ADDENDUM # 3

8/4/14
Solicitation #7548895

Title: Emergency Steam and Condensate Repair – Residence Halls, Rhode Island College

ARDEN PROJECT NUMBER	DRAWING NUMBER	REVISION NUMBER
44178	C3.0	C

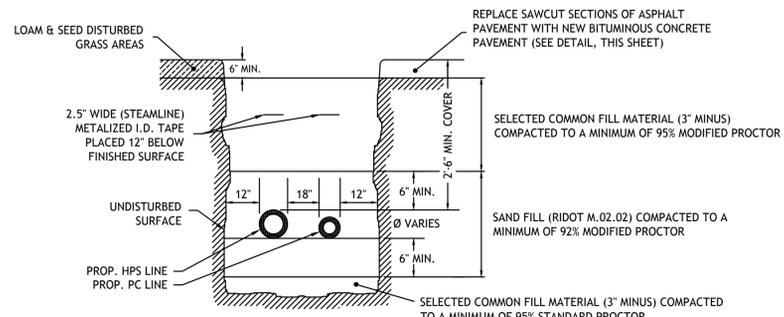
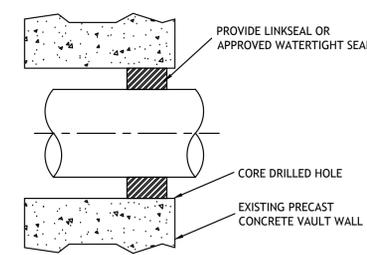
- There is a six to eight week lead time for pipe
- Drawings need to go to engineer for approval and then to Revanco for approval
- Paving will be a problem
- A surveyor also needs to be brought in prior to anything being done
- There is a requirement for polyethylene coating above and below, but no hazardous conditions exist

- Change 3'x3' access doors on the steam vaults to 6'x6'
- No onsite toilet facilities will be available to the Contractors. A portable toiler will be required.

Response: *We will delete the surveyor requirement on C3.0 however, all existing utility locations and elevations are still to be confirmed by the contractor prior to construction. Any new items found which do not match the plans must be brought to the Engineers attention prior to construction for review. No work shall proceed until authorized by the Engineer. Soil management requirements remain unchanged. With regards to the paving; the paving may be delayed, however this will be dependent on substantial completion date. Substantial completion will exclude final restoration. The contractor will need to provide a schedule for final restoration to be reviewed and approved by the College. A revised C3.0 has been uploaded to the State website if needed.*

ARDEN PROJECT NUMBER	DRAWING NUMBER	REVISION NUMBER
44178	H3.0	C

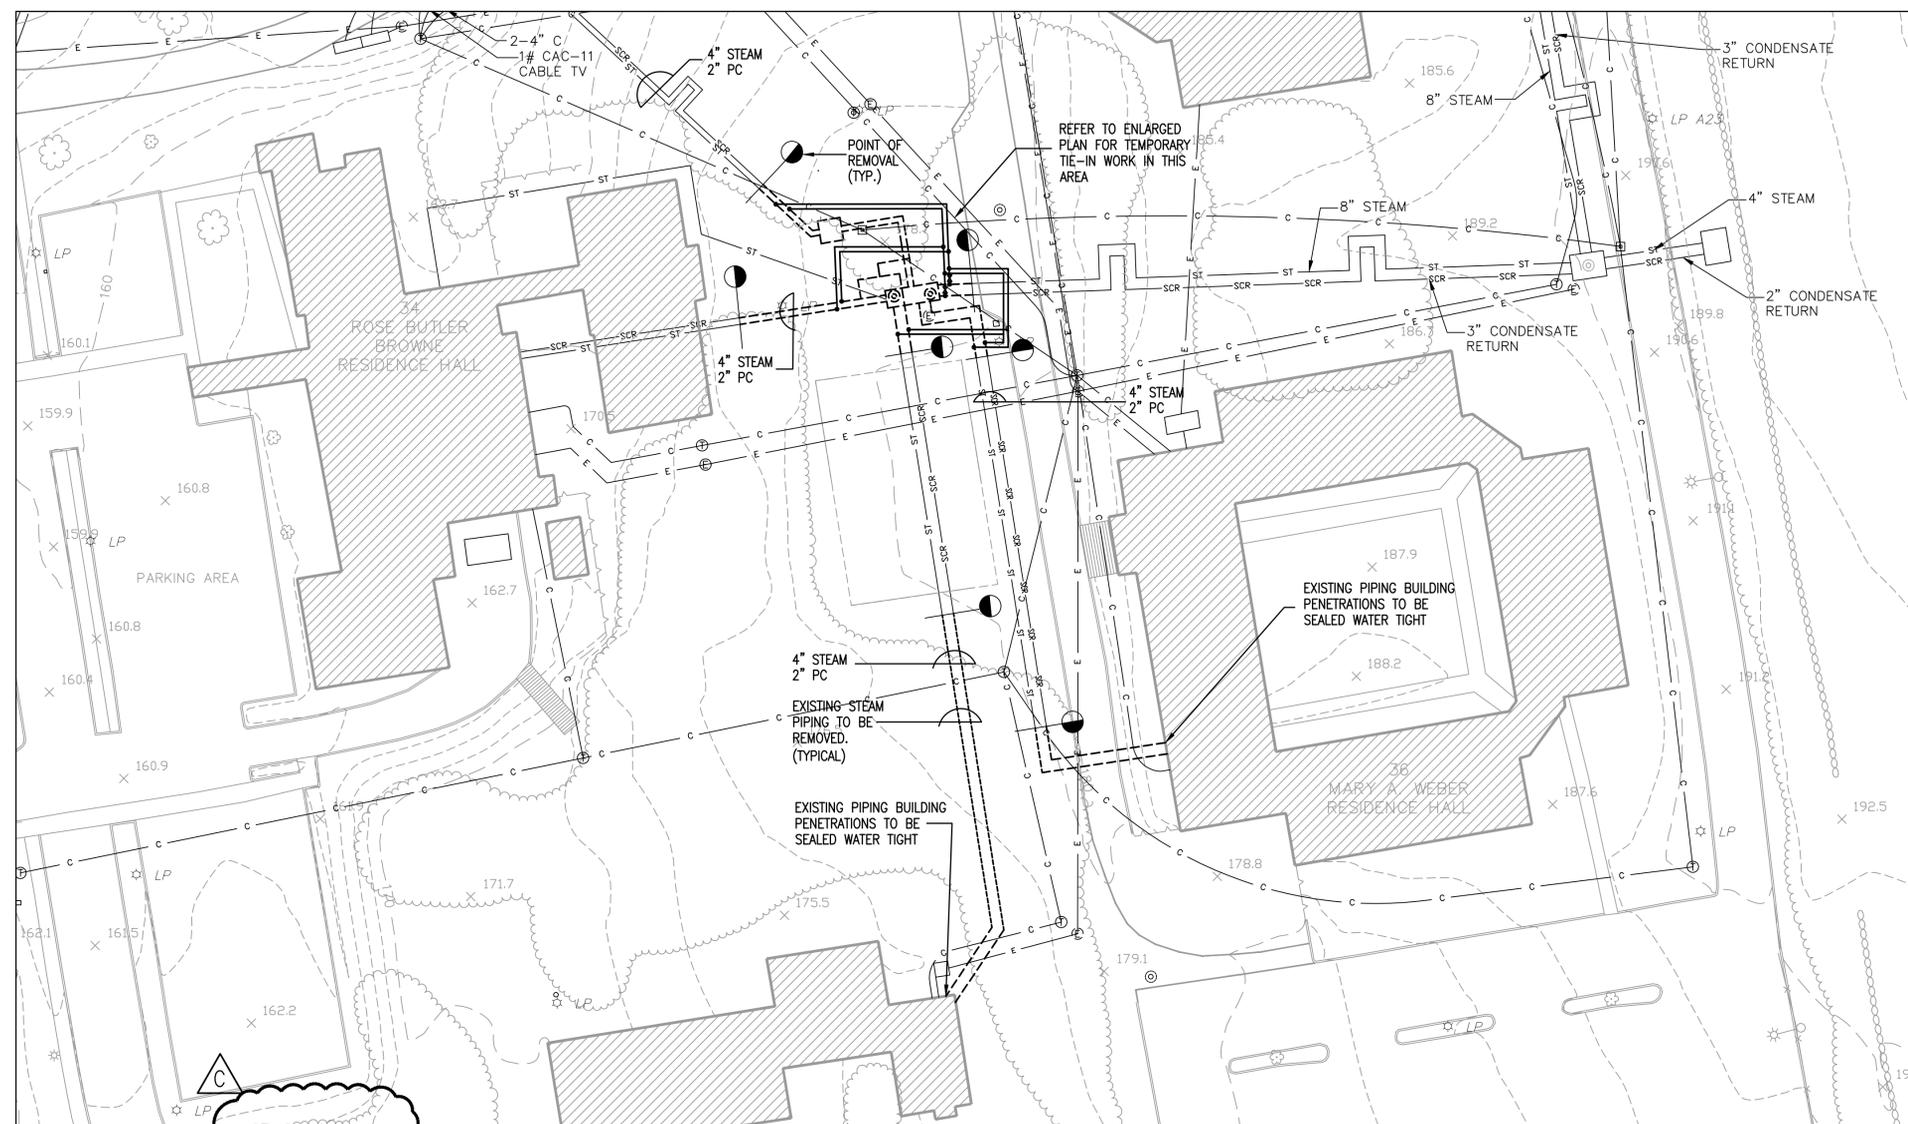
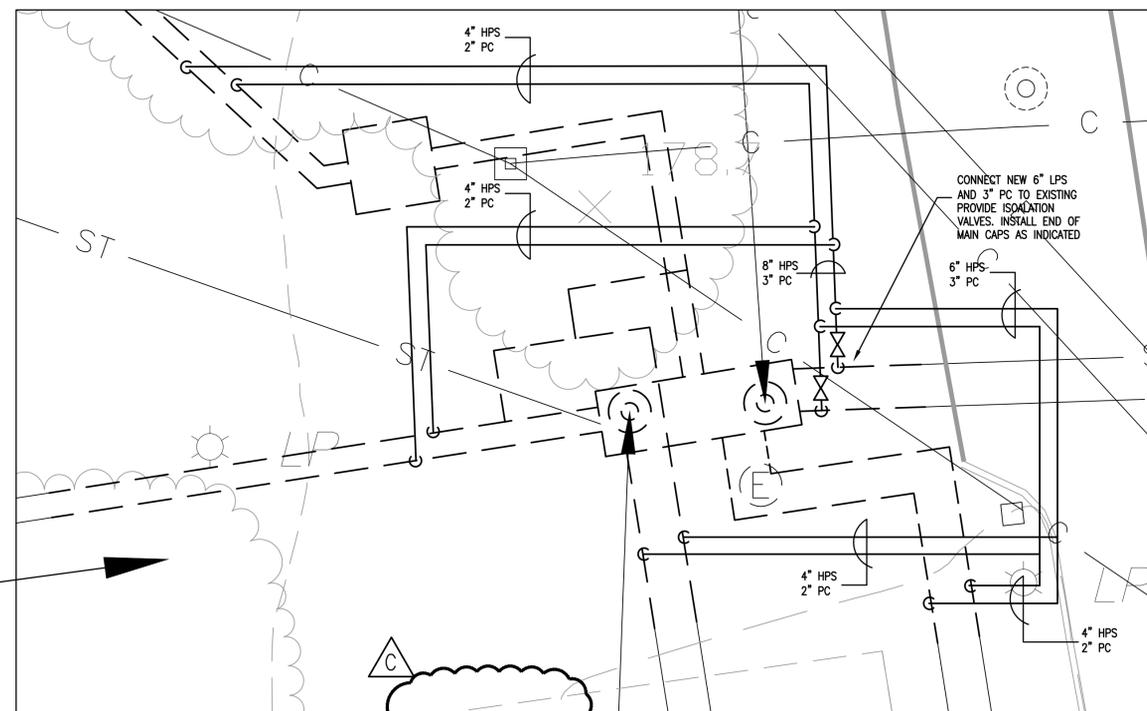
Question: Can we please confirm the scales on drawings H3.0 and H5.0. There are three different size drawings on those two pages that all have the same scale of 1"=30'-0".

Response: *The small temporary tie-in plan is not to scale. It is to be used for pipe sizing and notes only. H5.0 scale is correct. The large Demo plan on H3.0 is off a bit. H5.0 and site plans C1.0 and C2.0 can be used for scaling if needed. A new properly scaled H3.0 will be uploaded to the State website also.*
